<b>Location:</b>	<b>1431 Franklin Street</b>
<b>Assessor's Parcel Number:</b>	008 062100807
<b>Proposal:</b>	Major Conditional Use Permit and Regular Design Review to construct a 27-story (424-foot tall) 419,480 square feet office tower with a parking garage above grade.
<b>Applicant:</b>	TC II 1431 Franklin, LLC
<b>Phone Number:</b>	Kyle Winkler, Tidewater Capital, (510) 290-9901
<b>Case File Number:</b>	PLN20124
<b>Owner:</b>	TC II 1431 Franklin, LLC
<b>Planning Permits Required:</b>	Major Conditional Use Permit for large scale development; Regular Design Review
<b>General Plan:</b>	Central Business District
<b>Zoning:</b>	CBD-P Central Business District Pedestrian Retail Commercial Zone Height Area 7, no limit
<b>Environmental Determination:</b>	Determination Pending, Environmental analysis to be conducted prior to any discretionary action.
<b>Historic Status:</b>	Project site is located within an existing listed National Register historic resource, the Downtown Historic District Area of Primary Importance (API).

# LANDMARKS PRESERVATION ADVISORY BOARD

Case File: PLN20124  
Applicant: TC II 1431 Franklin, LLC  
Address: 1431 Franklin Street  
Zone: CBD-P  
Height Area: 7, No l

FLOOR PLAN (ROOF)

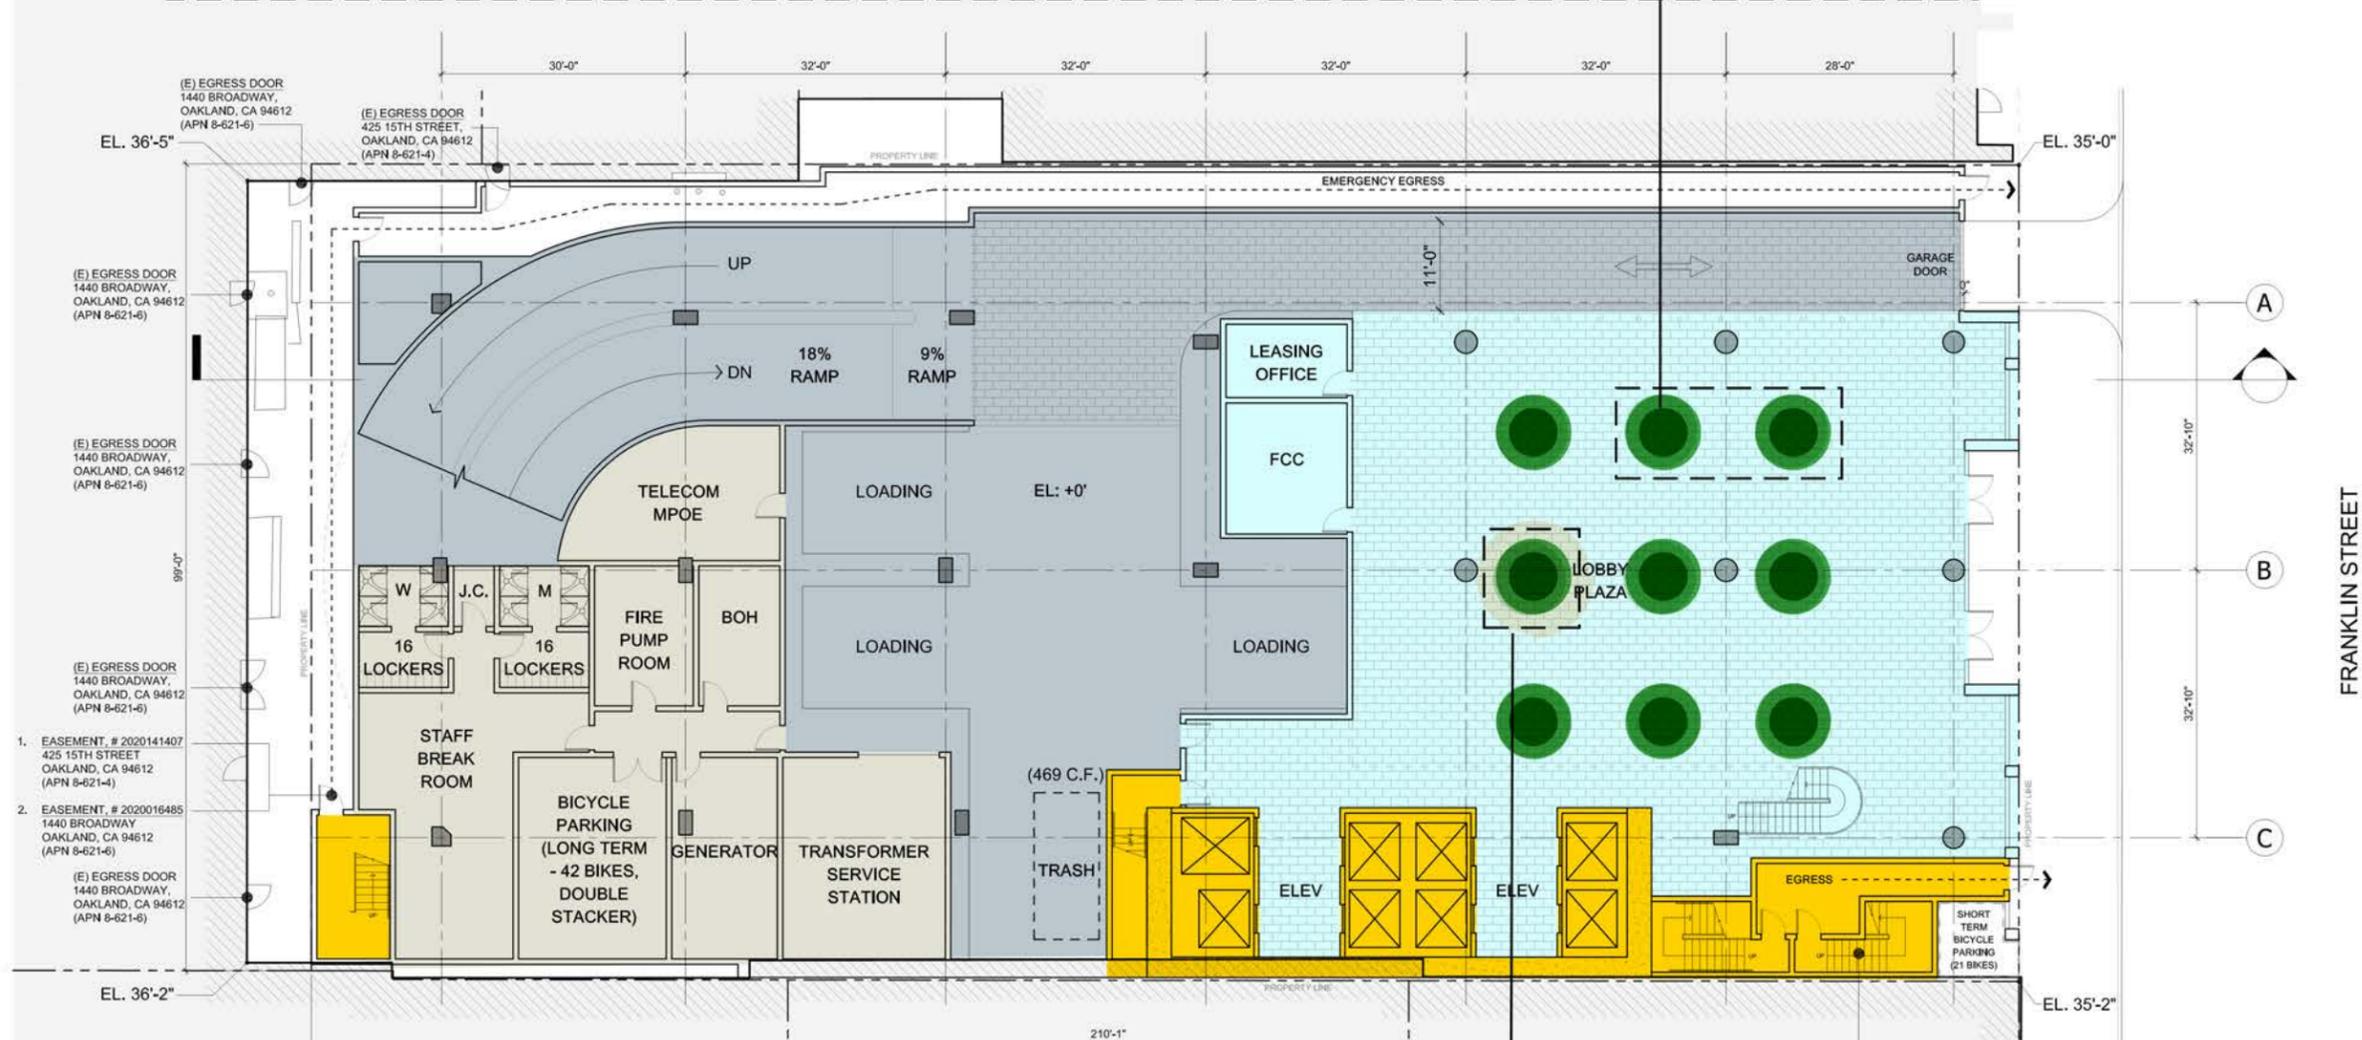
# 3.3.2 [sic] Size, place, and screen rooftop mechanical equipment, elevator penthouses, antennas, and other equipment away from the public view.			N	More information about the roof top space is still needed. Roof plan needs a legend. Provide dimensions of the space.
